BE02 0039 US

Office Action Summary	Application No. 10/537,518	Applicant(s) VAN SCHAIJK ET AL.	
	Examiner W. David Coleman	Art Unit 2823

DETAILED ACTION

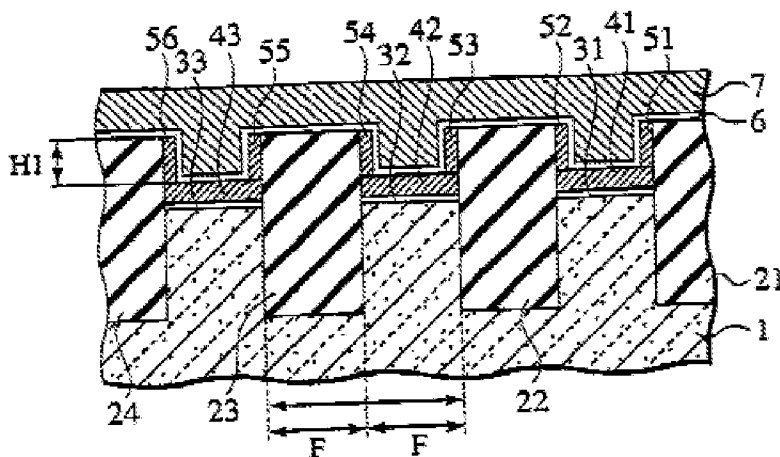
5. Pertaining to claims 1 and 11, Mori teaches a method for manufacturing a floating gate type semiconductor device on a substrate having a surface, the method comprising:

forming, on the substrate surface **1**, a stack comprising an insulating film **31,32** and **33**, a first layer of floating gate material **41, 42** and **43** and a layer of sacrificial material **91, 92** and **93**

forming at least one isolation zone **21, 22, 23** and **24** through the stack and into the substrate,

the first layer of floating gate material thereby having a top surface and sidewalls,

removing the sacrificial material **91**, thus leaving a cavity defined by the isolation zones and the top surface of the first layer of floating gate material. However, Mori fails to completely filling the cavity with a second layer of floating gate material **51, 52, 53, 54**, the first layer of floating gate material and the second layer of floating gate material thus forming together a floating gate. Nakamura teaches completely filling the cavity with the second layer of floating gate material. In view of Nakamura, it would have been obvious to one of ordinary skill in the art to completely fill the cavity with the second layer of floating gate material in the Mori semiconductor process because depositing the second floating gate material is not only limited to partially filling the cavity, but completely filling the cavity can obviously be performed to obtain a semiconductor memory device.
